New Albany Architectural Review Board
Monday, September 8, 2025 Meeting Minutes - Approved

ARB-54-2025 NAPLS Elementary School COA

**NEW ALBANY-PLAIN LOCAL SCHOOLS ELEMENTARY SCHOOL
CERTIFICATE OF APPROPRIATENESS**

project name	NPLSD Elementary School
prepared for	City of New Albany
date	August 20, 2025
date received	August 13, 2025

Development Review

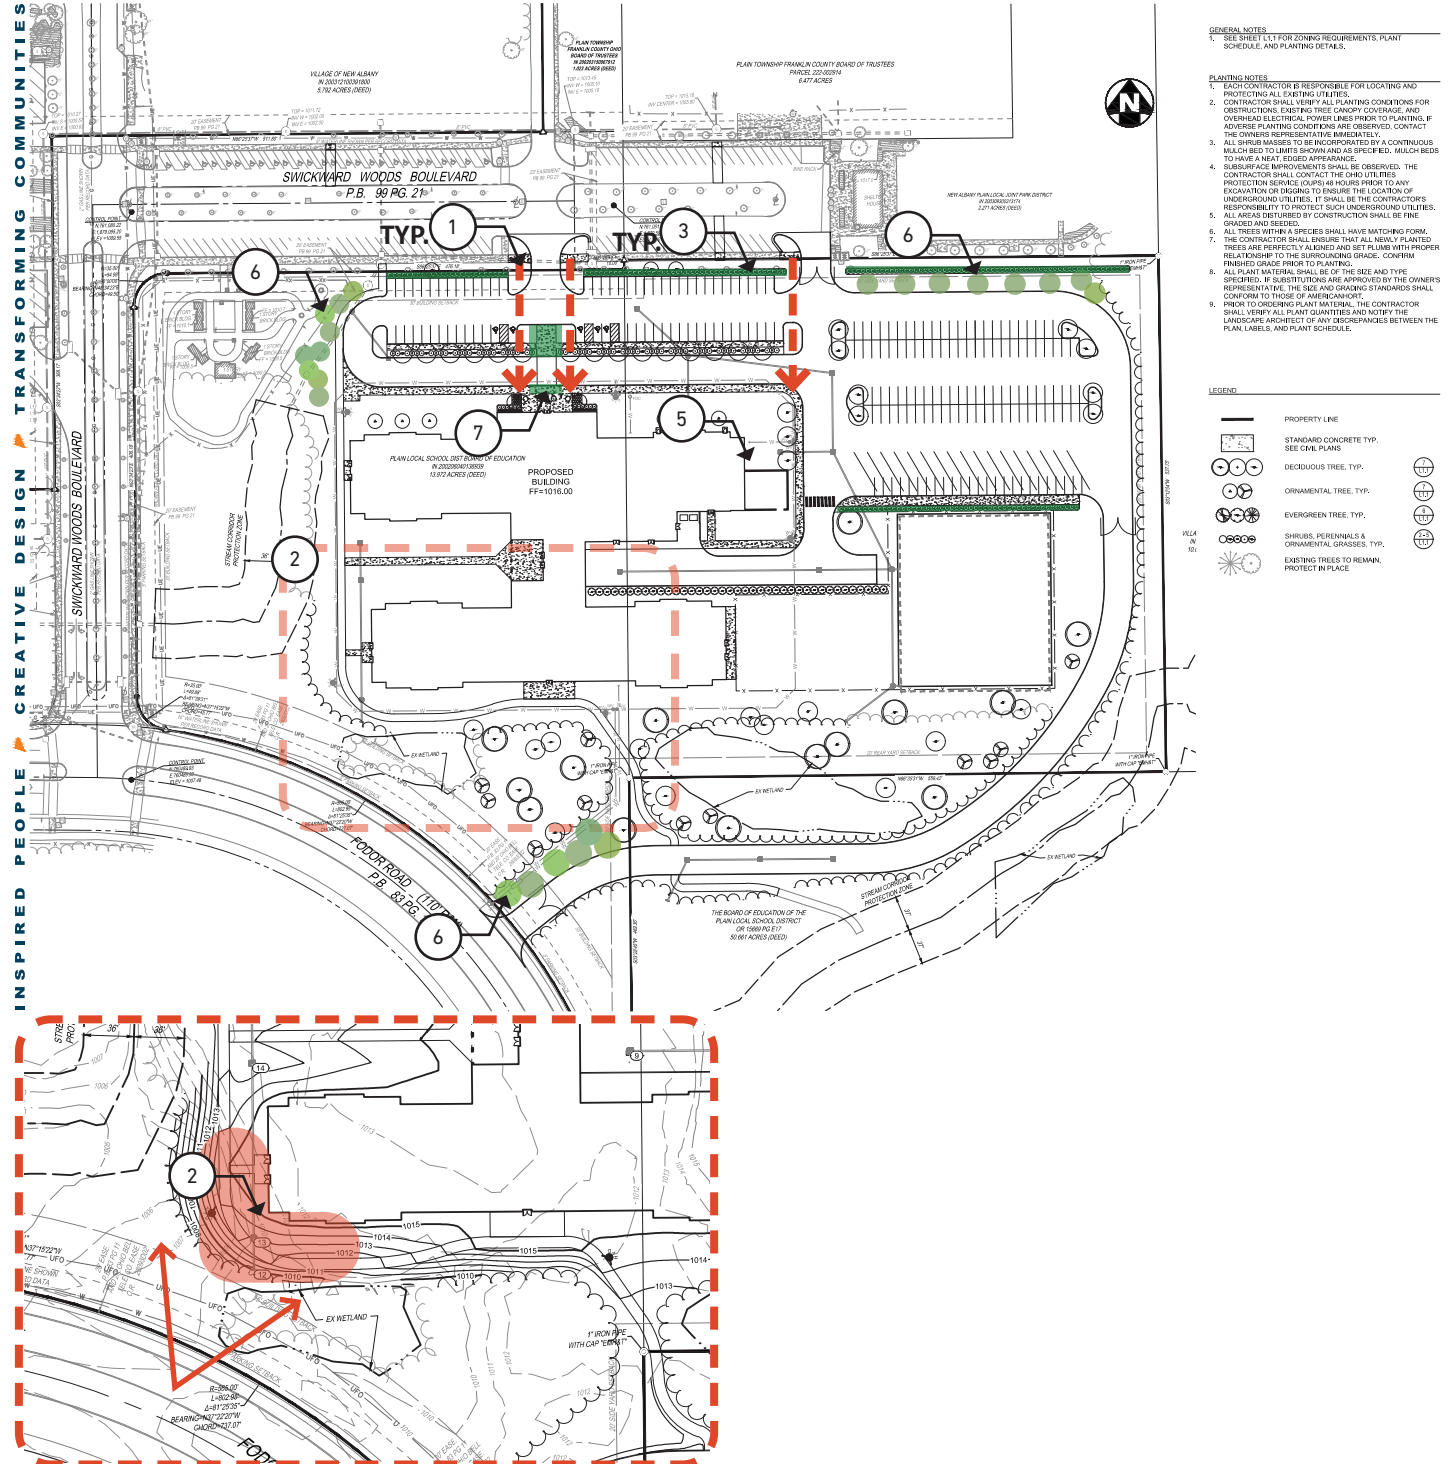
- 1. Adjust the proposed site plan to include additional safe pedestrian connections from Swickward Woods Blvd. to the main entrance. See diagram.
- 2. Review the proposed grading at the southwest corner of the current building footprint. Consider the proposed viewshed from the existing elevation at Fodor Road to the buildings FFE. The addition of a brick clad wall or strategic planting may help to lessen the visual impacts of this condition. See diagram.

- 3. Revise the proposed planting plan to include parking lot screening that meets the minimum 42” height requirement at time of installation. Refer New Albany Code of Ordinances, Chapter 1171.06 (b). See diagram.
- 4. Revise the proposed planting plan and schedule to properly reflect the intended planting of evergreen species on the current site plan.
- 5. Provide plant material adjacent the proposed mechanical yard for proper screening. See diagram.
- 6. Revise the proposed planting plan to include approved deciduous shade trees for additional site screening. See diagram.
- 7. Consider revising the proposed planting plan to include additional plant material within the center portion of the main entry promenade. This both reduces the amount of paved surface in the area and provides a more significant viewshed when approaching the main entrance. See diagram.
